# Infotainment System Reboots Under Cold Temperatures

**Service Category** Audio/Visual/Telematics

YEAR(S)	MODEL(S)	ADDITIONAL INFORMATION
2016	iA

Figure 2.

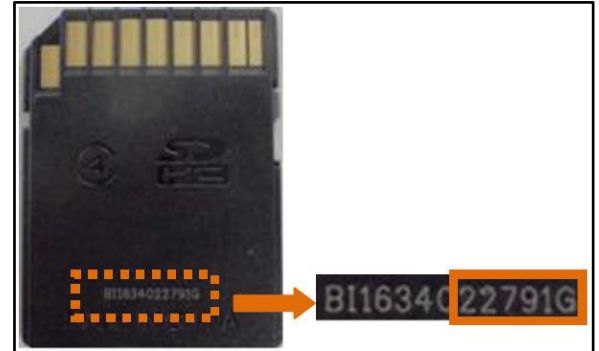
4. Locate the serial number on the SD card.

5. Identify the lot number of the SD card.

Do the last six digits of the SD card lot number match ANY of the lot numbers listed in the table below?

- **YES** — Replace the SD card.
- **NO** — This bulletin does NOT apply. Continue diagnosis using the applicable Repair Manual.
